2020-12-02

User Stories for IEC/IEEE 60802 system definition

Figure 11: Principles

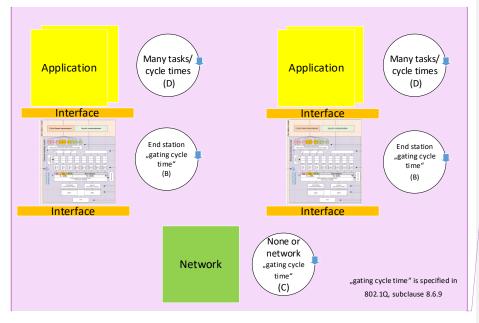
Commented [MS42]: Is it "end station interface" meant in the drawing or network interface of the end station?

Figure 15: Clock usage model

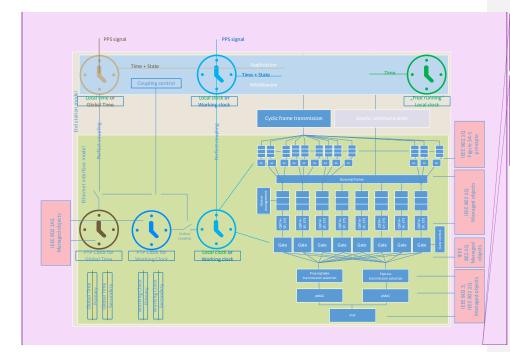
Commented [MS44]: I would like to propose an update of this drawing, as this drawing raised many comments also in D1.2. It is useful, in my view, for the reader, to associate the clocks governing the timely behavior to their relevant sections in an end station.

Commented [MS45R44]: I would still like to add the proposal I have done for this drawing, in Figure 14a(next page). The proposal currently shown in Figure 14 seems to be only one way of using the clocks. Personally, I find it very complex, due to the mixing of the PTP clock at the application level. Perhaps needed in some situations, but in my view, definitely not needed for all end stations which will be TSN enabled (thus it could be optional).
